STATE OF MAINE
DEPARTMENT OF TRANSPORTATION
16 STATE HOUSE STATION
AUGUSTA, MAINE 04333-0016

January 23, 2015
Subject: **Bridge**
State WIN: 016705.00
Location: **Howland**
Amendment No. 1

PIER NO. 1 ELEVATION

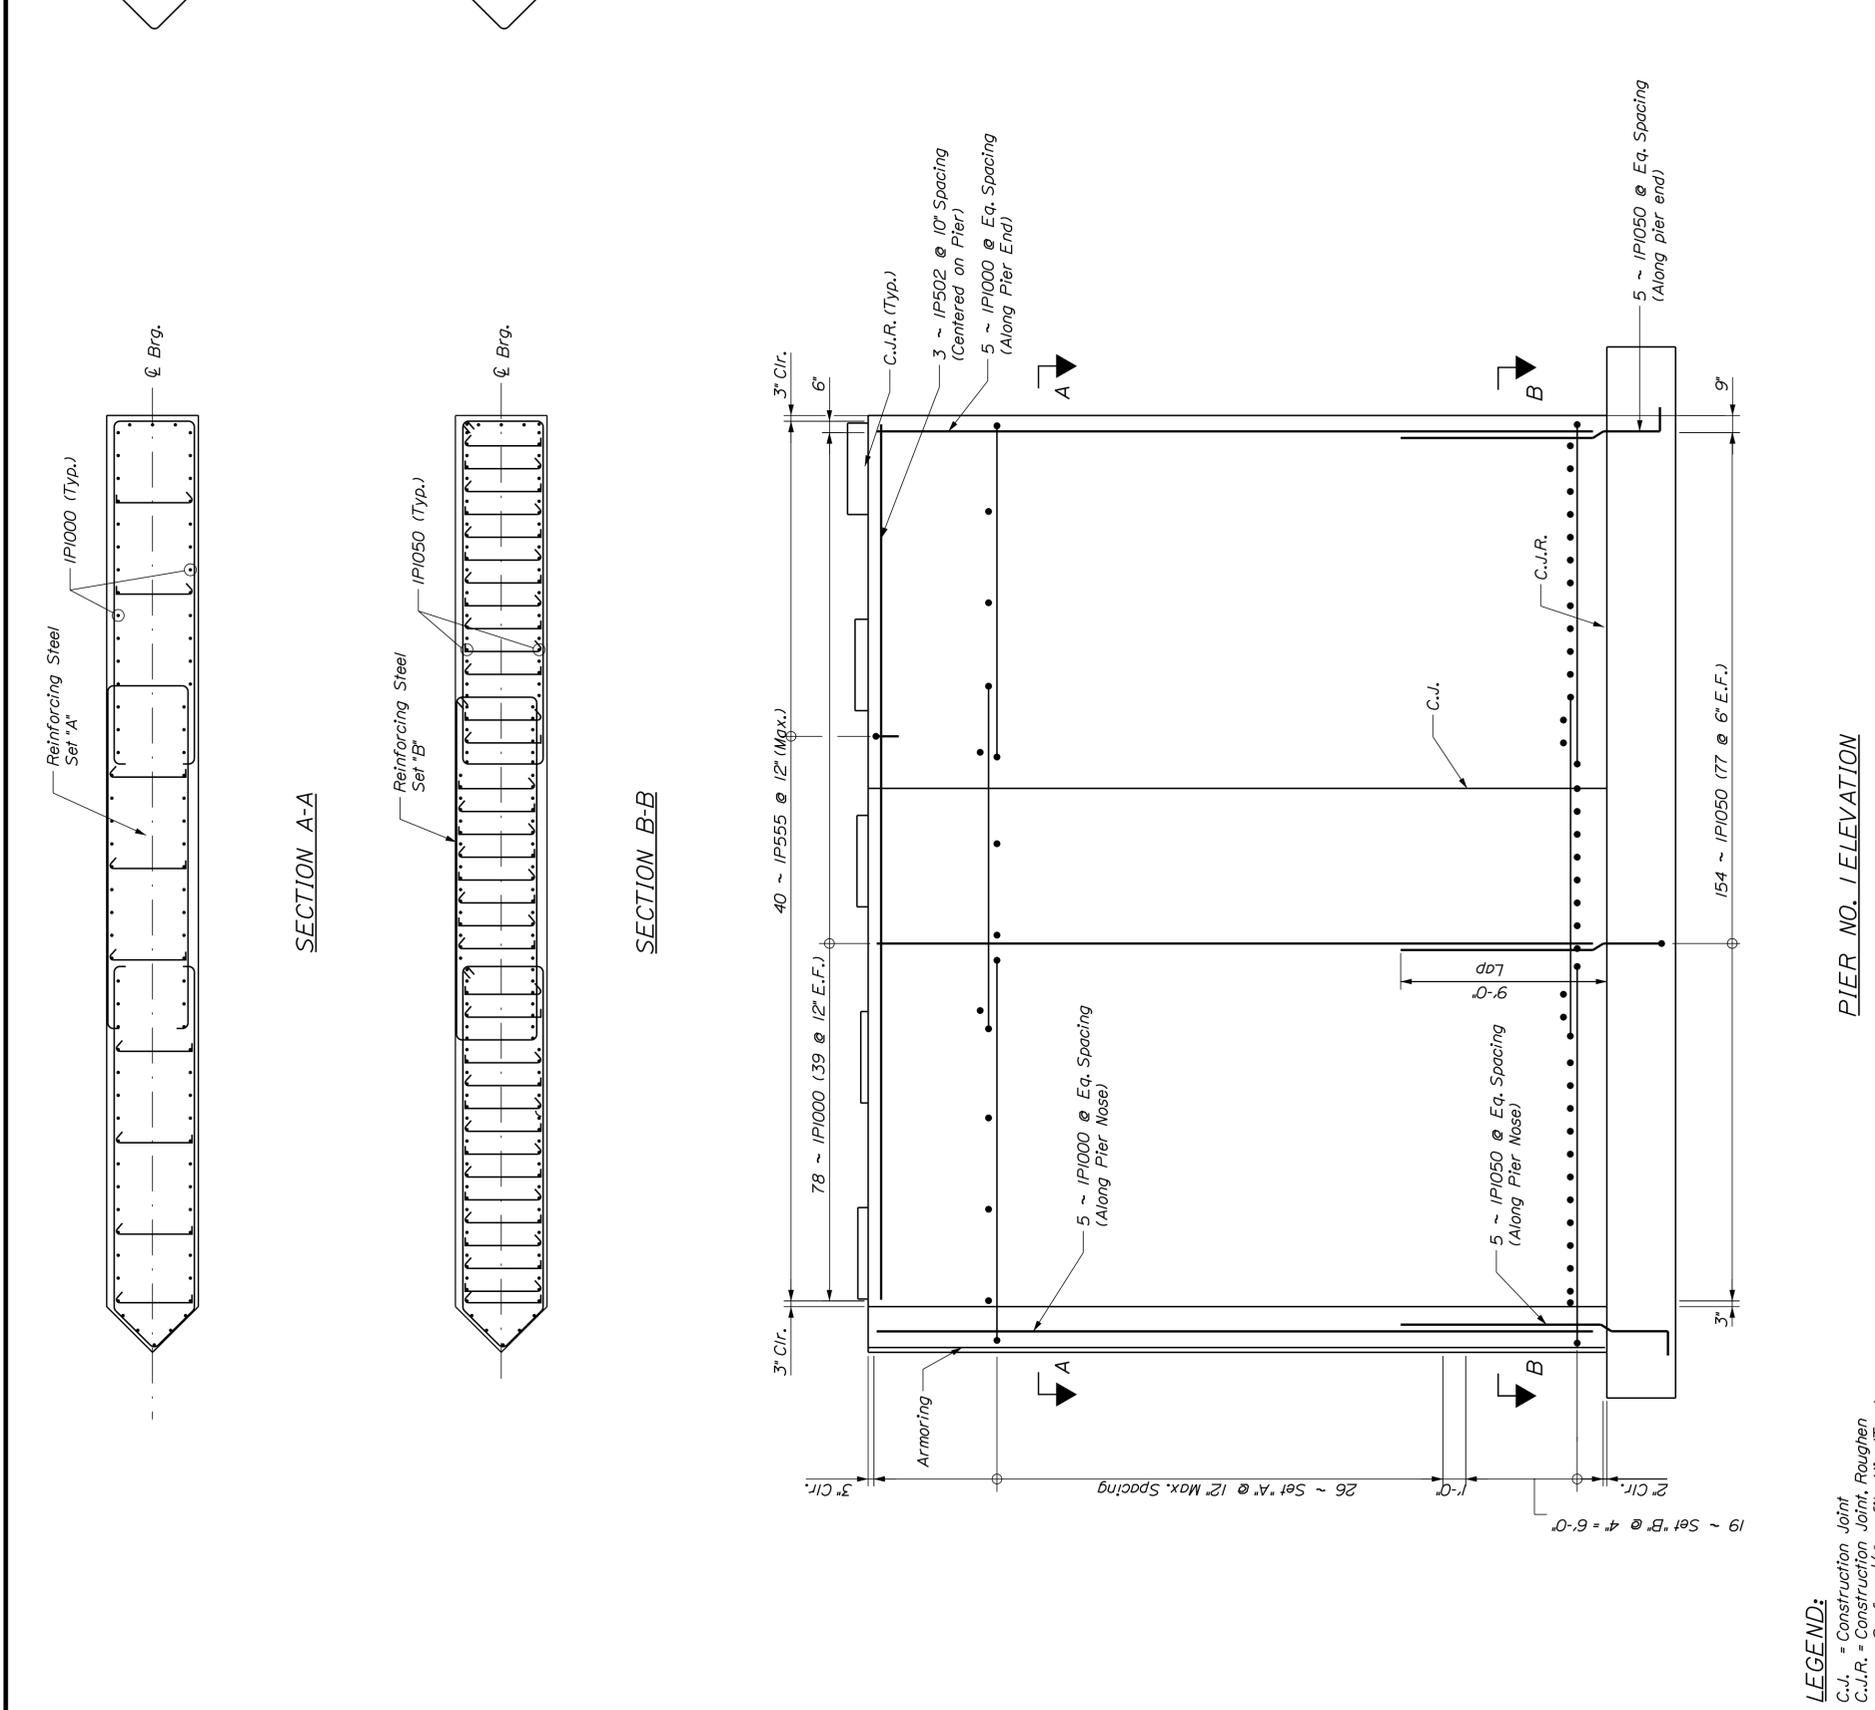
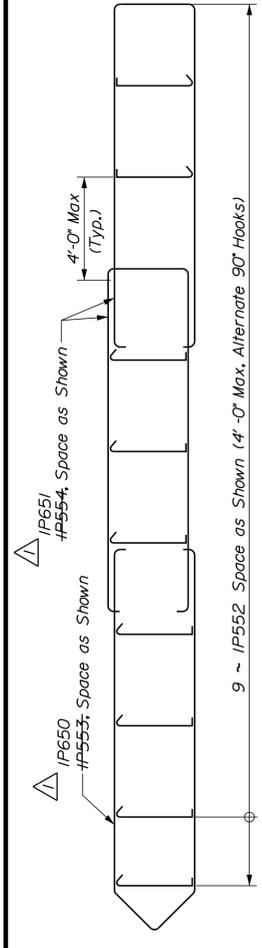
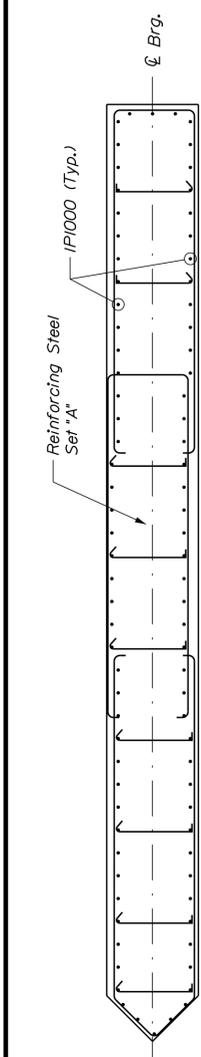
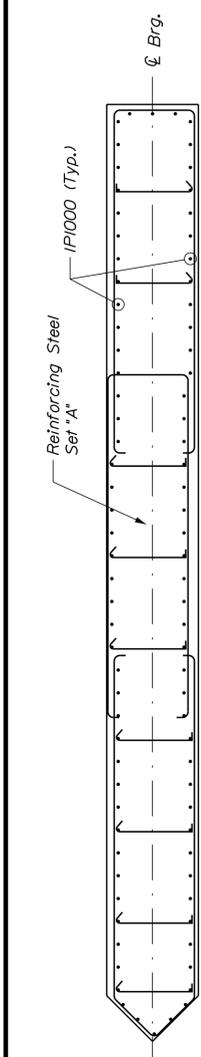
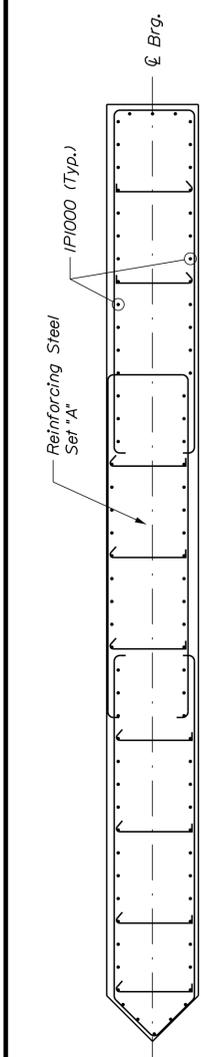
REMOVE, Sheet 73, "PIER 1 REINFORCING PLAN & ELEVATION", and **REPLACE** with the attached revised Sheet 73, "PIER 1 REINFORCING PLAN & ELEVATION" revision date 1/21/2015.

PROJ. MANAGER	NLB	BY	DATE
CHECKED-REVIEWED	RHM	SAM	
DESIGN-DETAILS	RHM		
DESIGNS-DETAILS			
REVISIONS	Δ	DATE	DESCRIPTION
REVISIONS 4			FIELD CHANGES
REVISIONS 3			
REVISIONS 2			
REVISIONS 1			
P.E. NUMBER	1/21/2015		DSM: Bar mark change
DATE
